Taunton, MA
Wastewater Treatment Facility
Phase I Improvements
CWSRF 4605
Addendum No. 3
July 30, 2021

This Addendum No. 3 forms a part of the Contract Documents and modifies the Bidding Documents dated July 2nd, 2021 as noted below. Acknowledge receipt of this Addendum in the space provided in the Bid Form. Failure to do so may subject the Bidder to disqualification.

SECTION
SCALE: 3/8" = 1'-0" (15 S-2.1)

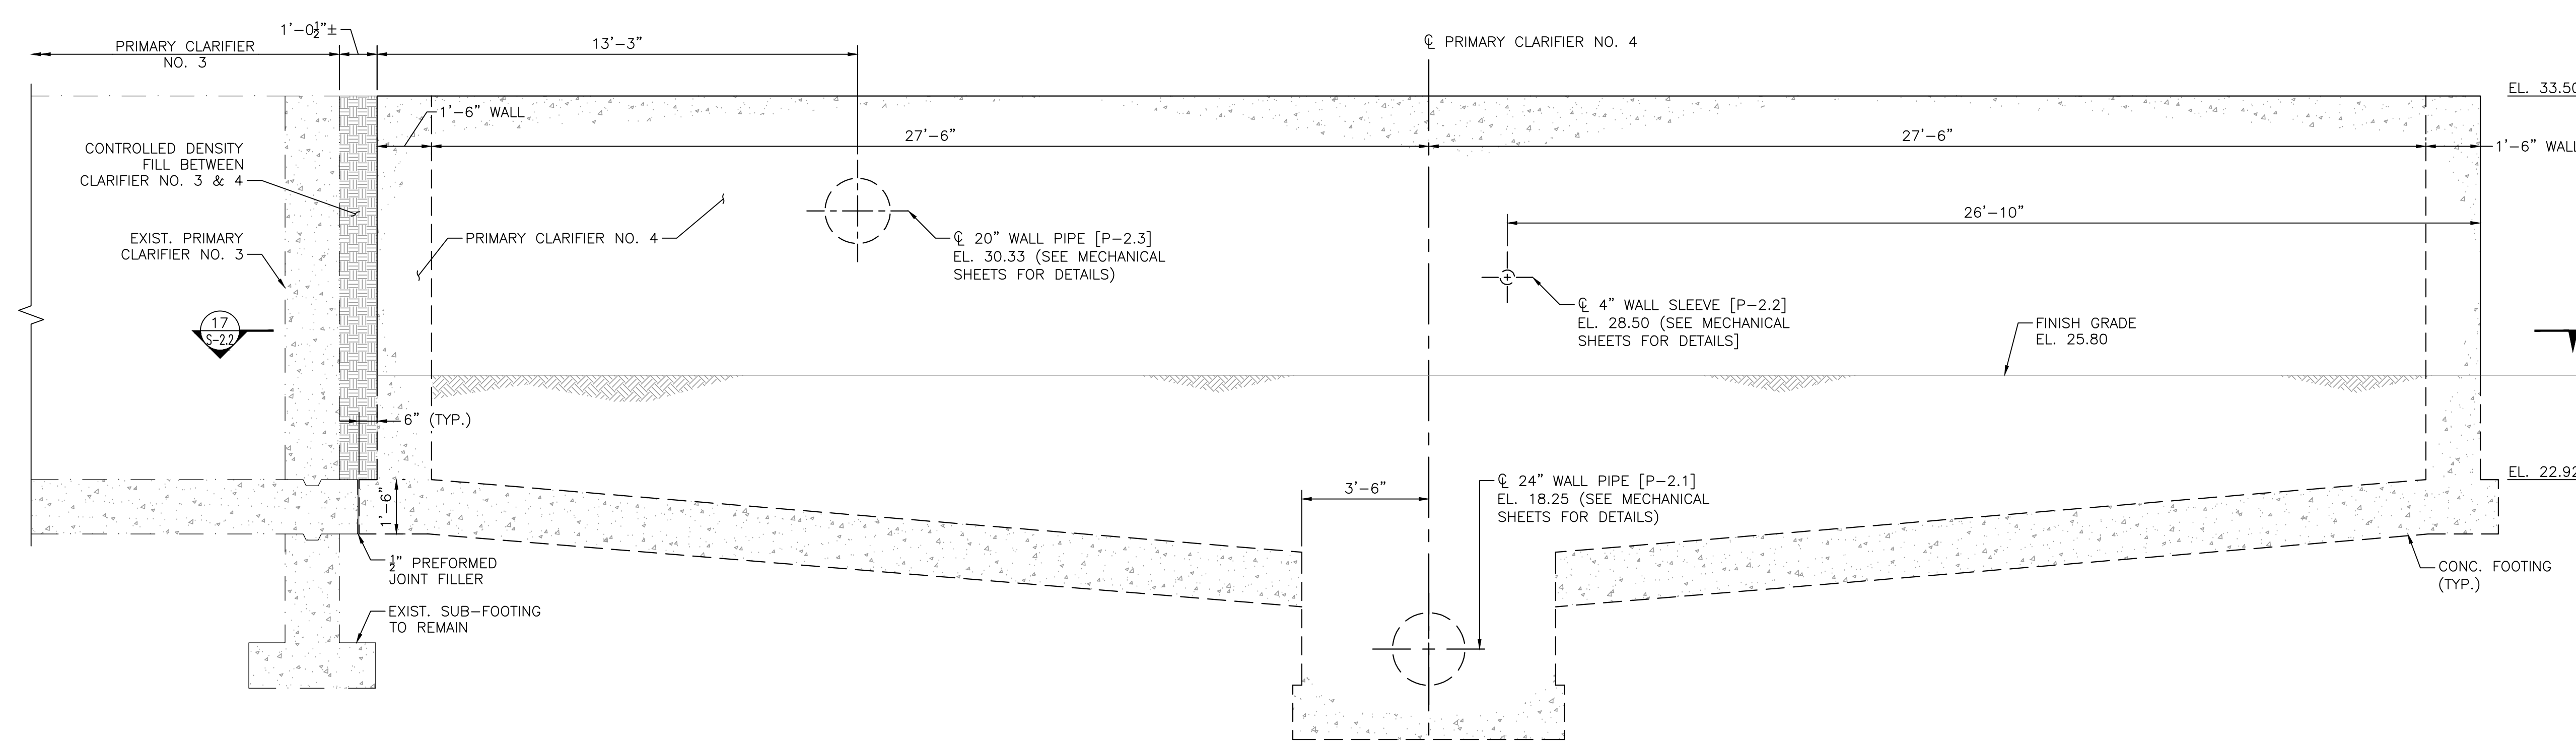
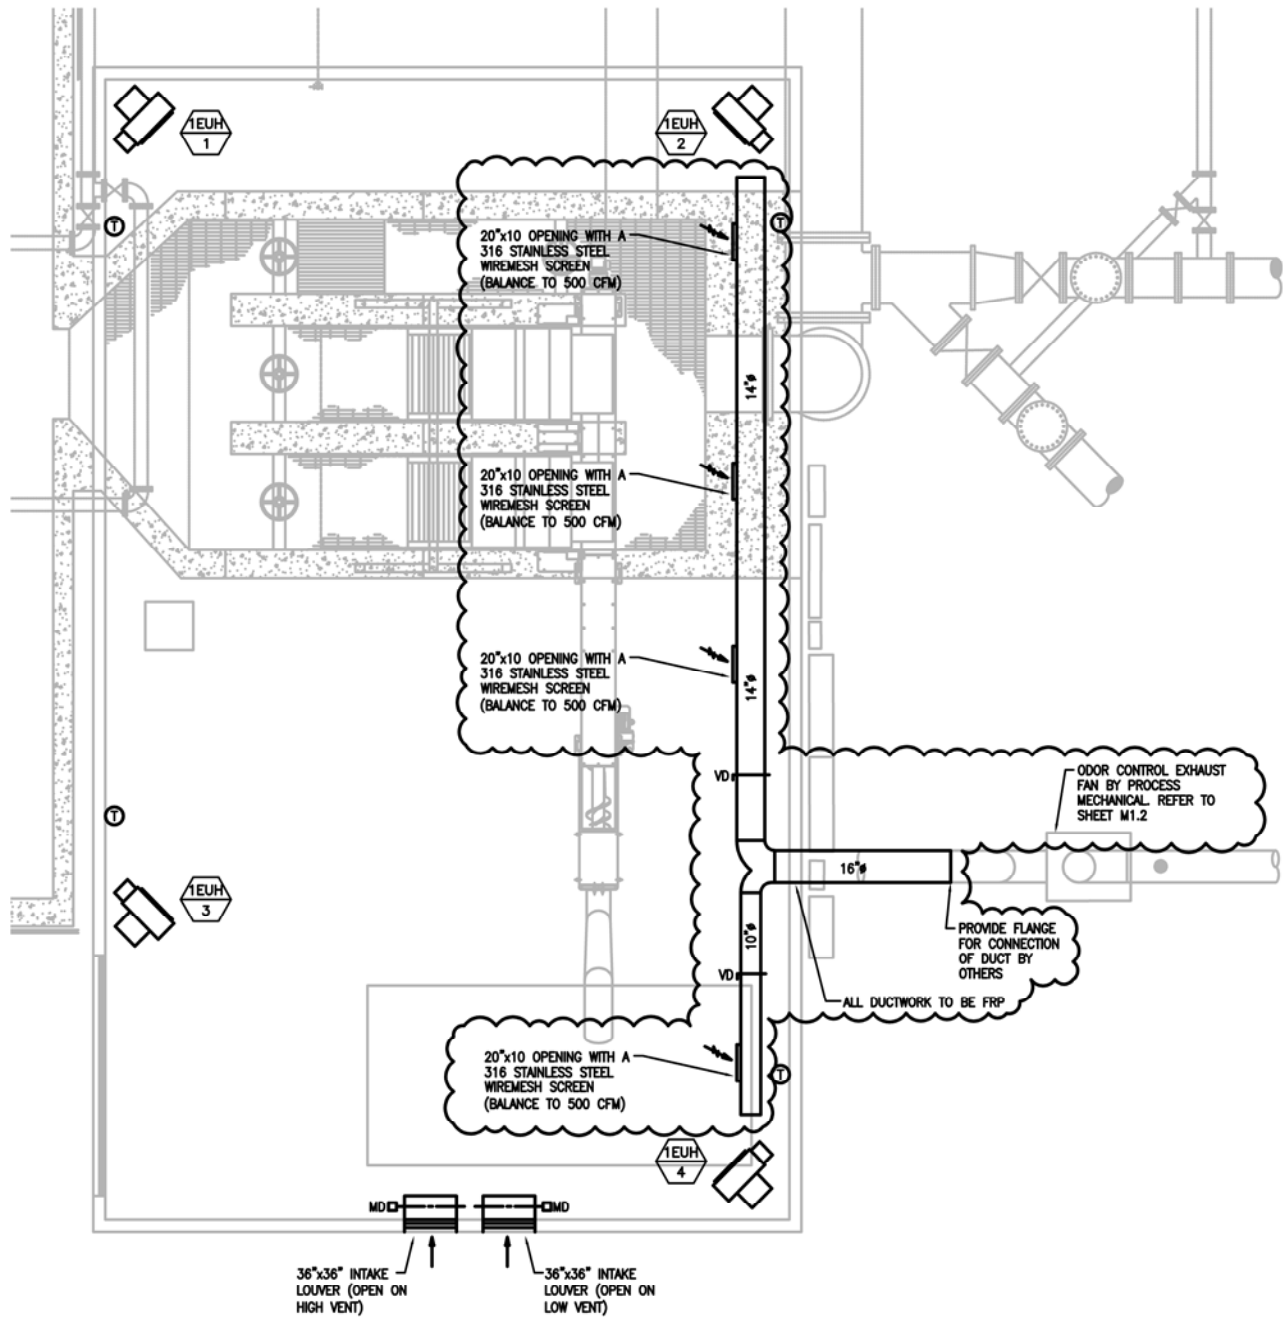
DELETE Primary Clarifier Plans and Elevations S-2.1 and **ADD** the attached Primary Clarifier Plans and Elevations S-2.1 Re-Issued Per Addendum

SKH-1
Taunton WWTF Improvements
Phase 1
Scale: 1/8"=1'-0"

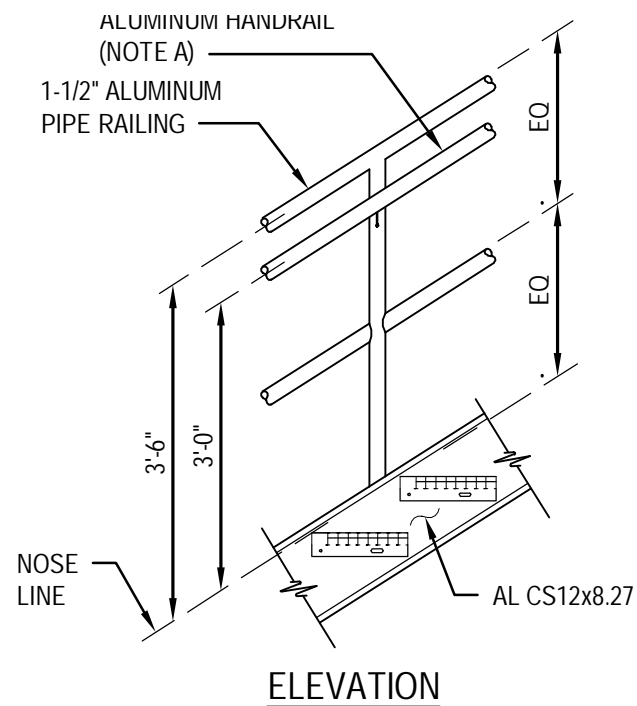
Drawing H-1.2

- See sketch SKH-1 on sheet. Added under Item 3, below.

8. Could you please provide the location for Screening Control Panel "CP-1300"? **Refer to this addendum.**
9. Please provide drawings on the BFA piping. It appears to be in the HVAC scope of work (per M-1.2) but no drawings/routing were provided. **See Sketch SKH-1 attached.**

Primary Sludge Pump
Station Stair Detail

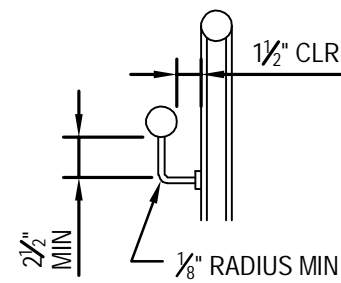
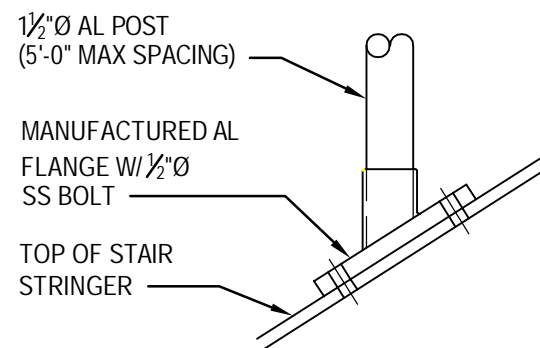
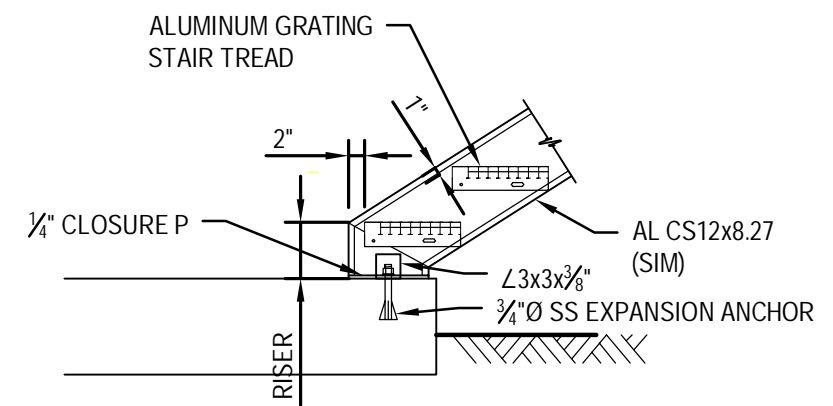
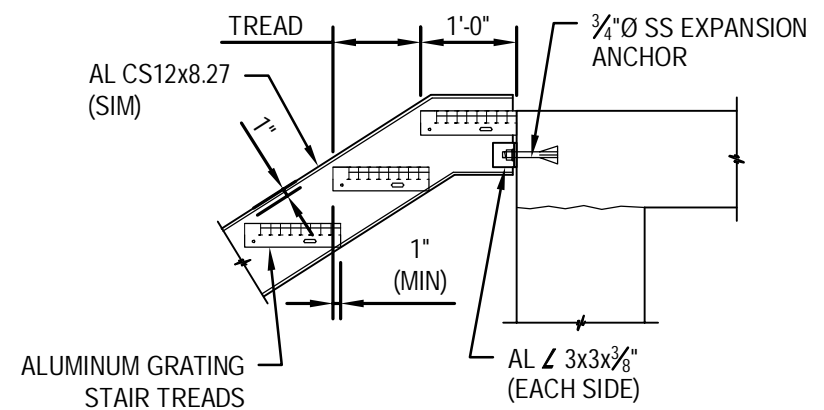
15. On plans S-2.3 to S-2.5, (2) exterior staircase replacements are shown. Please provide fabrication details for the replacement metal stairs. **Detail has been provided.**

- supply any attachment details of the stairs to the existing walls. **Stairs are metal, see attached architectural details (Item 3)**
25. Sheet S-6.2 Detail 20/S-6.4 notes a 10" x 12" shear key. Is this a continuous shear key? If not, please supply the spacing of this shear key along the footing. Please confirm the key size. **Shear key is continuous, but is 10"Wx2"H, NOT 12"H.**

61. Please provide detail on metal staircases from primary sludge pipe gallery roof to ground. Reference drawing S-2.5. **Refer to this addendum, Item 3**

- A. HANDRAIL TO TERMINATE INTO A POST OR ANOTHER RAIL AT THE TOP AND BOTTOM OF STAIRS
